REGIONAL REVIEW FINDING

ARC REVIEW CODE: R702261

Submitting Local Government: City of Atlanta
Name of Proposal: Midtown Heights

Review Type: Development of Regional Impact

Design Suggestions for Residential Lobby/Plaza & Mitigation Measure For Vehicular Drive

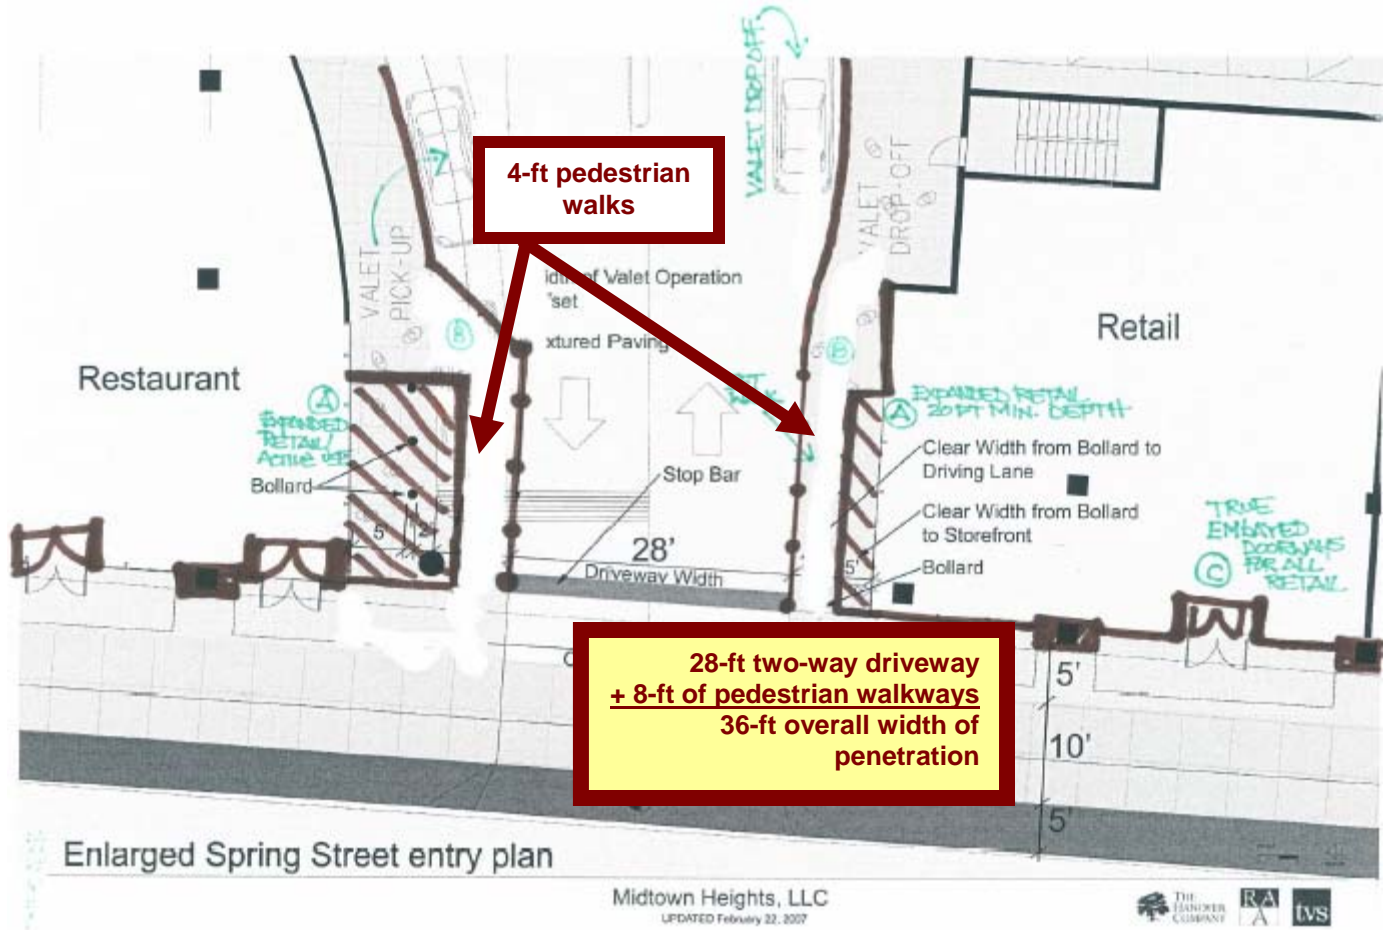
The DRC: Revisions to the plaza primarily have been changing rectangular planters to trapezoidal shapes; the design still does not respond effectively to holding the corner, or pulling out of façade to better meet the sidewalk clear zone and mitigate width and breadth of space dedicated to vehicular uses. Additionally, per City staff, it was noted that the creation of raised planters in this location requires variation for relief from SPI zoning. According to SPI zoning, planters can not be any higher than 36 inches tall, and trees must be planted at grade. Understanding that the structure is located below the supplemental zone at this location, the DRC encourages designers to study Atlantic Station's at-grade tree plantings that occur above ground and upon structure lining both sides of 17th Street between the Downtown Connector and State Street. Furthermore, the DRC recommends shifting of the 16th Street doorway approximately 15-25 feet westward to better hold the corner and eliminate the need for the raised planter and potential "public safety hazard nook" it creates as currently proposed. Overall, further mitigation of expansive open space and vehicular zones is necessary (drawing attached to illustrate recommendations).

- F.** Extension of lobby storefront to edge of 16th Street Clear Zone eliminates “public safety hazard nook” and replaces raised planter with active use.
